# **Board Finance & Audit Committee Meeting and Special SMUD Board of Directors Meeting**

Date: Tuesday, September 16, 2025

Discuss certifying the **California Environmental Quality Act (CEQA) Oveja Ranch Solar Project (Project) Final Environmental Impact Report (EIR)**, including adoption of the **Findings**; adopt the **Mitigation Monitoring and Reporting Program** for the **Project**; and approve the **Project**.  
Presentation: 10 minutes  
Discussion: 5 minutes
2. Matthew Powell  
Laurie Rodriguez

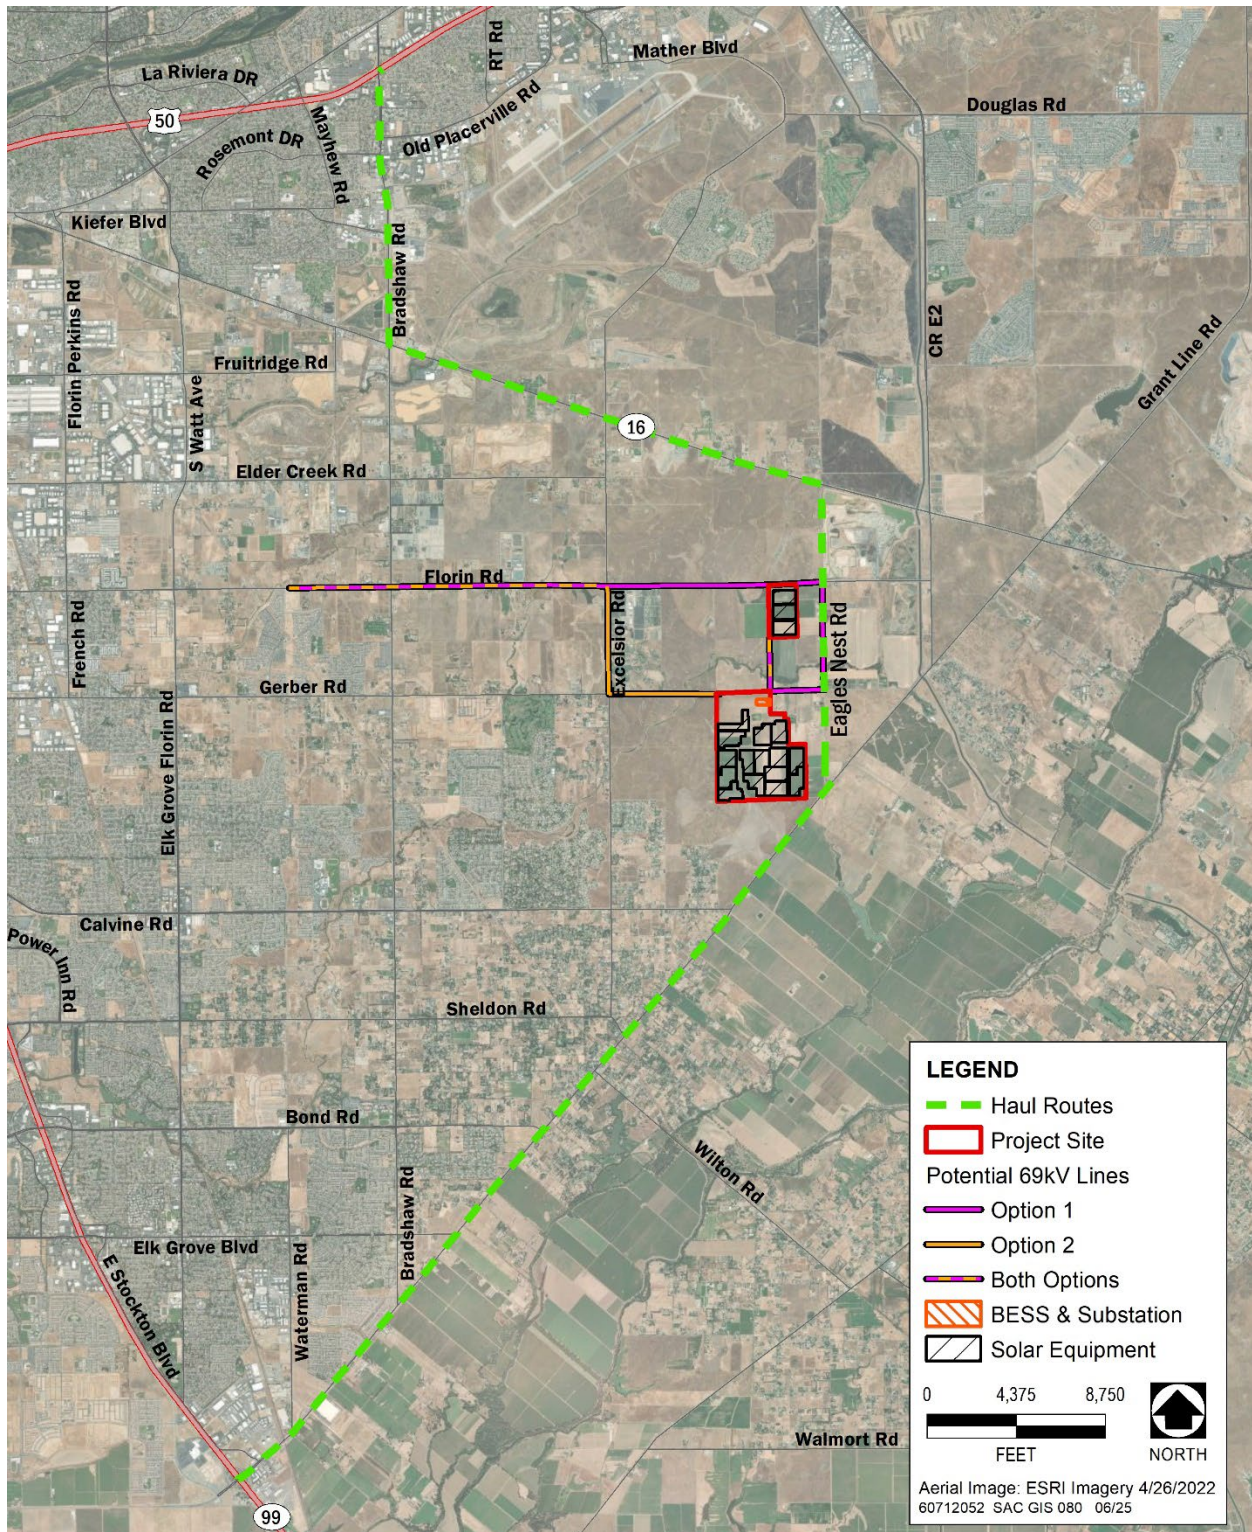
1. Page 3.17-7 – Construction – Please provide an illustration of the haul route specifying which Sacramento County roads the construction vehicles will take access from U.S. Highway 50 and California 99 to the project. 1-1

<b>Letter 1 Response</b>	<b>Gary Gasperi, Sacramento County Department of Transportation March 19, 2025</b>
1-1	<p>Please see the anticipated haul routes vehicles will take during construction in the figure on the following page. No revisions to the EIR are necessary.</p>
1-2	<p>As requested by the Sacramento County Department of Transportation (SacDOT), the following paragraph on page 3.17-7 of the Draft EIR has been edited:</p> <p>Up to 64 daily construction-related truck trips for delivery of materials and hauling would be spread over an eight-hour workday during the peak period of construction in terms of trip generation, which is during the site preparation phase. In addition, a maximum of 263 worker trips would occur during the a.m. and p.m. hours before and after each workday during the peak construction phase, resulting in a total of up to 654 daily vehicle and truck trips added each day to local roadways during the peak trip-generating phase of construction. If the equipment and material delivery and haul trips are spread evenly across an eight-hour workday, and the worker commute trips occur during the first and last hour of the eight-hour workday, the peak hourly trip generation would be approximately 483. It is assumed that the worker trips will be distributed along area roadways. <u>A more detailed, focused Local Transportation Analysis (LTA) is required only when a project's final use is expected to generate greater than 1000 daily trips or 100 peak hour trips. However, an LTA is not required for project-related construction traffic. Therefore, because the number of daily and peak trips is below the threshold, an LTA is not required for this project, and the volume on any single roadway segment will fall below 100 peak hour vehicle trip ends, thereby avoiding the need for a more detailed, focused Local Transportation Analysis (LTA) based on this threshold beyond what is provided in this analysis.</u> Furthermore, work hours during the construction season would likely be longer than 8 hours to make maximum use of each workday, thus worker arrival and departure would likely typically occur before and after main commuter hours</p>
